TOYOTA SERVICE NEWS

Bulletin No. 2

November, 1981

MODEL Celica, Corona, Pickup Corolla (California only)

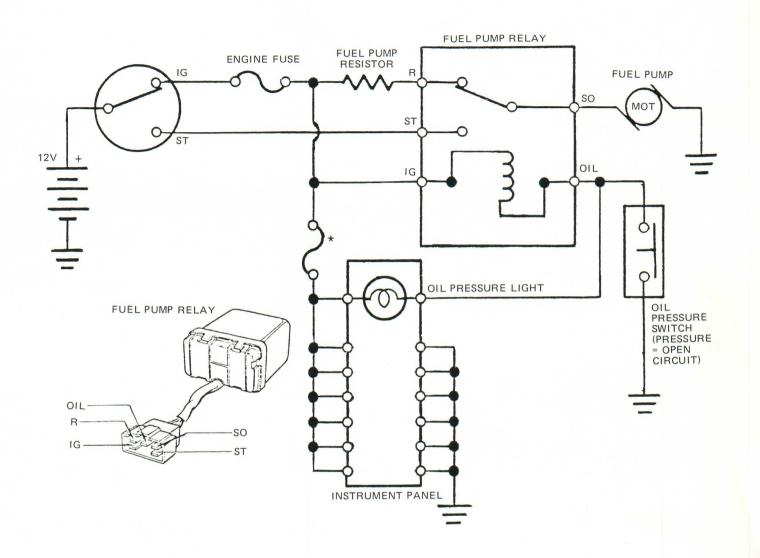
In February and March of 1975 (depending on the model of car) the fuel pump relay was changed. The exact serial numbers of the change are not available and since the relays are interchangeable,

the only way to be sure which relay you are working with is by part number. The part number is printed on the cover for easy identification.

OLD PART NO. 28300-20020 28300-12030 NEW PART NO. 28300-20021 28300-12031

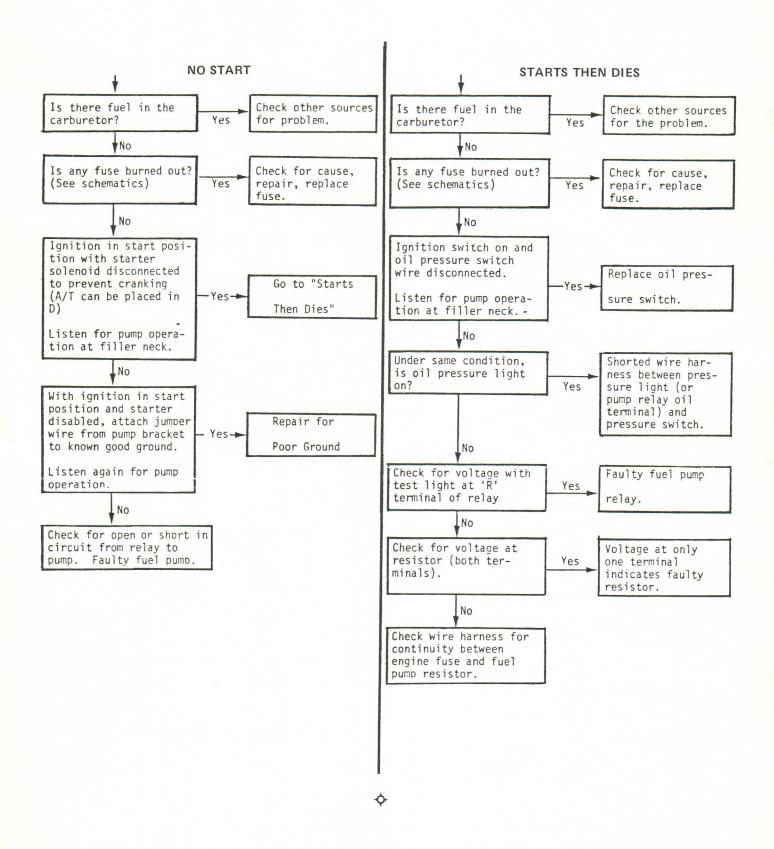
This article contains an electrical schematic drawing for the NEW type fuel pump relay as well as troubleshooting procedures for each of the four vehicle lines utilizing the electric fuel pump.

You will note that a blown fuse to the oil pressure

warning light* will allow a ground to be established from the printed circuit through the bulb (bulb may glow dimly) and back to the fuel pump relay, causing the relay to switch to the START position. Thus, the fuel pump will not operate once the engine is running with this fuse blown.
